5 Kooloora Avenue, Freshwater

Geotechnical Comments for Section 4.55

We have reviewed the existing geotechnical report, the original plans, and the 16 amended plans by Rachel Hudson, job number 199, drawings numbered YH-01-DA to YH-16-DA, Issue Section 4.55, dated 24/2/23.

LOWER FLOOR PLAN – showing test locations

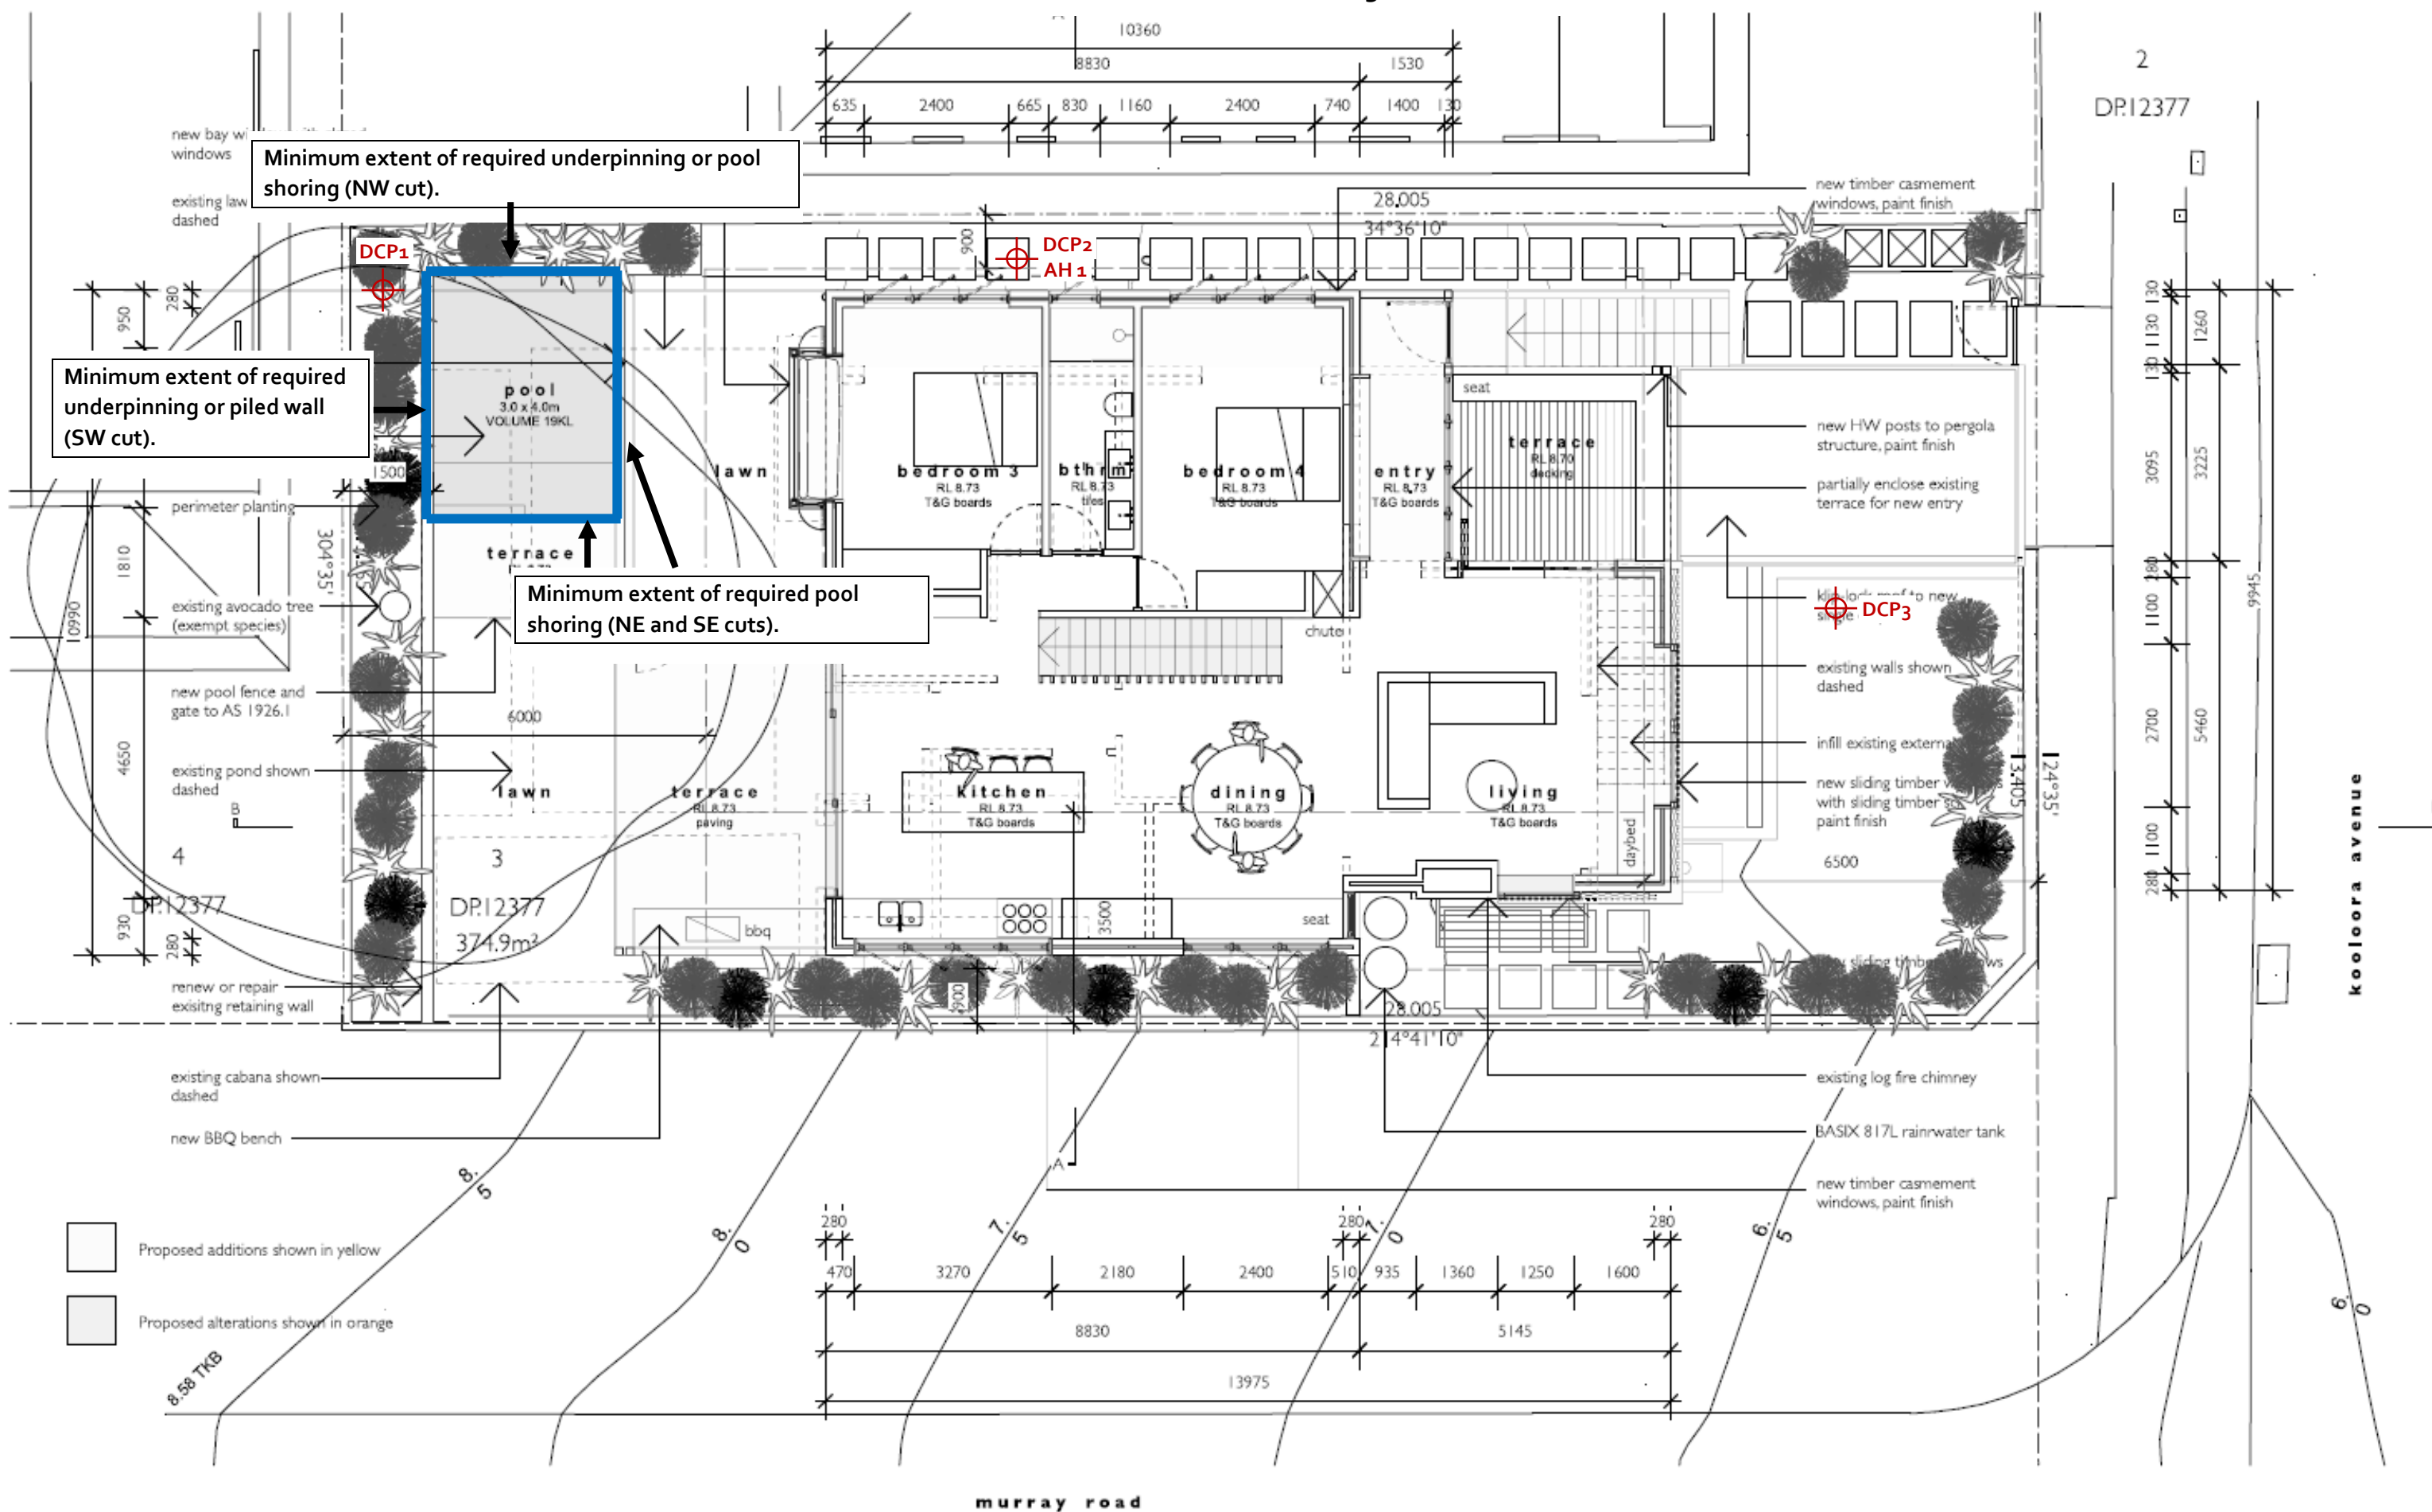
It is recommended a secant or contiguous pile wall be constructed along the NW side and SW side of the excavation where underpinning is not required before the excavation commences. See the Lower Floor Plan attached for the minimum extent of the required shoring shown in blue. Secant piers are the preferred option but if contiguous piers are used, the gaps between the piers are to be grouted closed as the excavation is lowered so no material moves through the wall. The piers can be temporarily supported by bracing and/or embedment below the base of the excavation but are to be tied into the house structure during construction.
